DONALD C. COOK NUCLEAR PLANT UNIT NO. 1

AMENDMENT TO FACILITY OPERATING LICENSE

Amendment No. 18  
License No. DPR-58

ATTACHMENT TO LICENSE AMENDMENT NO. 18

FIGURE 3.2-1 AXIAL FLUX DIFFERENCE LIMITS AS A FUNCTION OF RATED THERMAL POWER

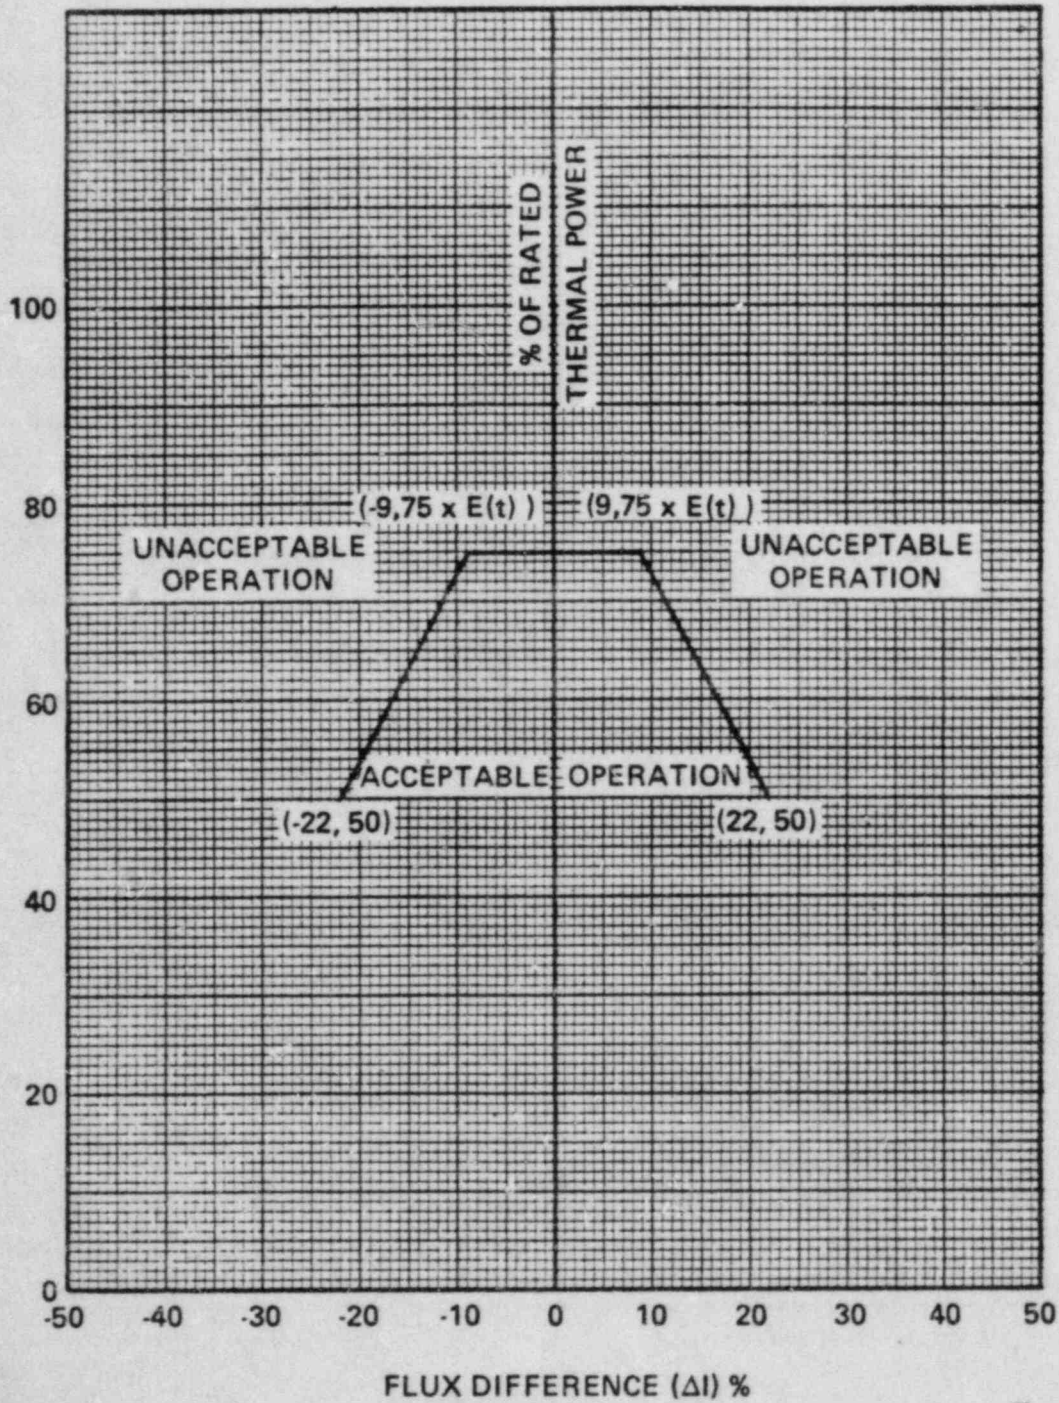
- 2) The indicated AFD is within the limits shown on Figure 3.2-1. Otherwise, reduce THERMAL POWER to less than 50% of RATED THERMAL POWER within 30 minutes and reduce the Power Range Neutron Flux-High Trip Setpoints to  $\leq 55\%$  of RATED THERMAL POWER within the next 4 hours.

- b) Surveillance testing of the Power Range Neutron Flux Channels may be performed pursuant to Specification 4.3.1.1.1 provided the indicated AFD is maintained within the limits of Figure 3.2-1. A total of 16 hours operation may be accumulated with the AFD outside of the target band during this testing without penalty deviation.

- c) Surveillance testing of the APDMS may be performed pursuant to Specification 4.3.3.6.1 provided the indicated AFD is maintained with the limits of Figure 3.2-1. A total of 6 hours of operation may be accumulated with the AFD outside of the target band during this testing without penalty deviation.
- b. THERMAL POWER shall not be increased above  $75\% \times E(t)$  of RATED THERMAL POWER unless the indicated AFD is within the  $\pm 5\%$  target band and ACTION 2.a) 1), above has been satisfied.
- c. THERMAL POWER shall not be increased above 50% of RATED THERMAL POWER unless the indicated AFD has not been outside of the  $\pm 5\%$  target band for more than 1 hour penalty deviation cumulative during the previous 24 hours.

Figure 3.2-3 E(t) Normalized Core Power as a Function of Cycle Burnup

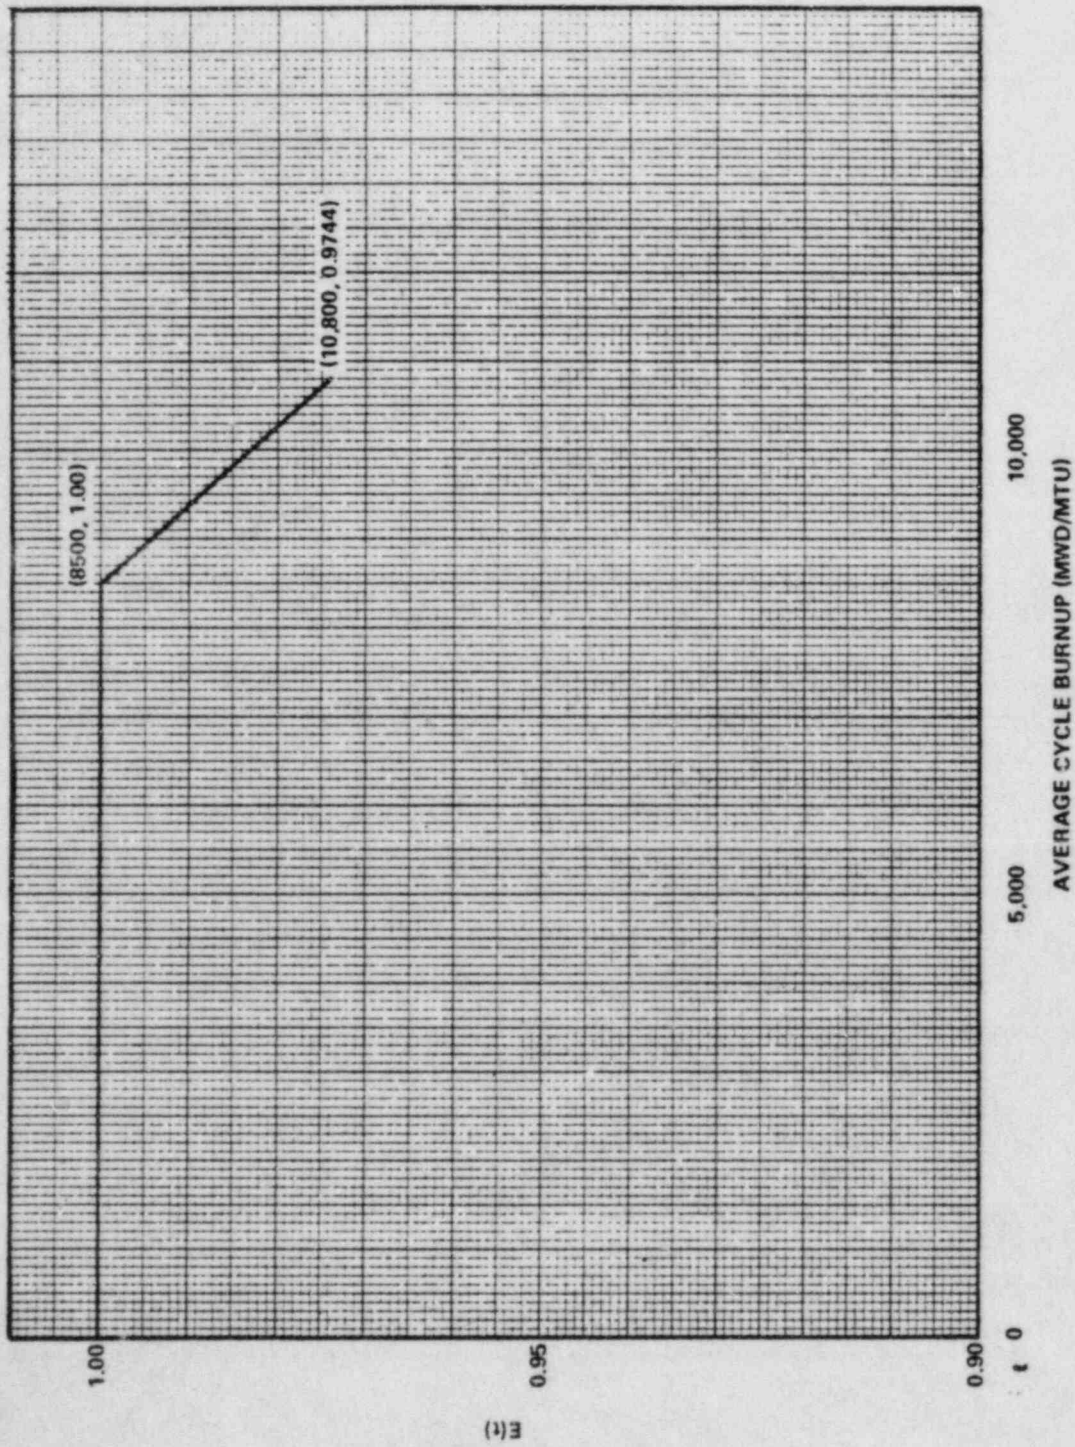
$$F_Q(Z) \leq \frac{[1.95]}{P} [E(t)] [K(Z)] \text{ for } P > 0.5$$

$$F_Q(Z) \leq [(3.90)] [E(t)] [(K(Z))] \text{ for } P \leq 0.5$$

$E(t)$  is defined on Figure 3.2-3,

Figure 3.2-4 Target Axial Flux Difference at RATED THERMAL POWER as a Function of Cycle Burnup

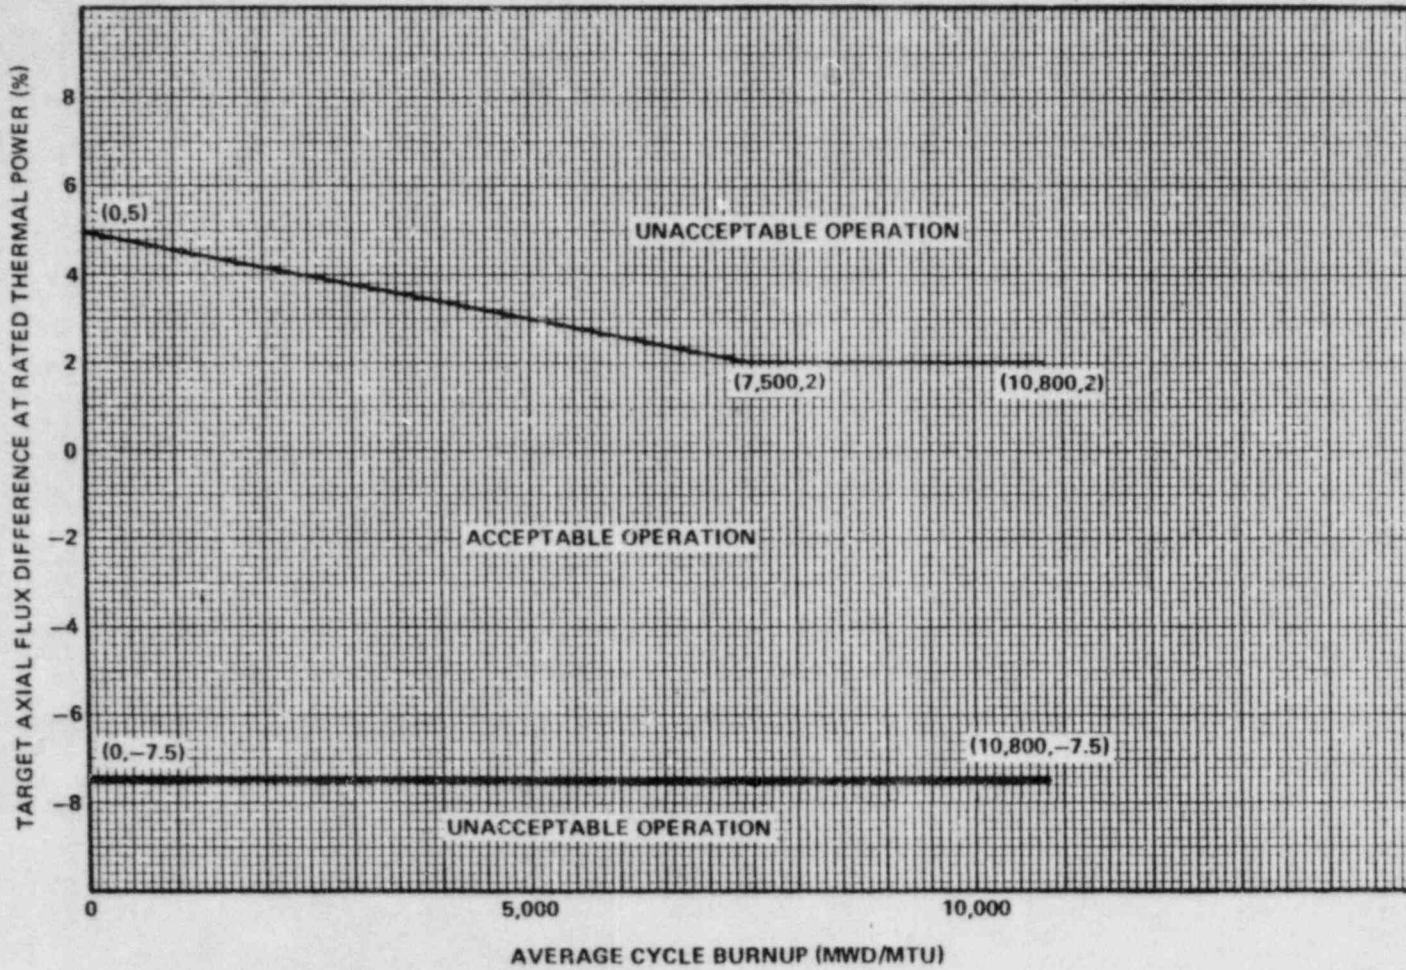
3.2.1 The indicated AXIAL FLUX DIFFERENCE (AFD) shall be maintained within a +5% target band (flux difference units) about the target flux difference shown on Figure 3.2-4.
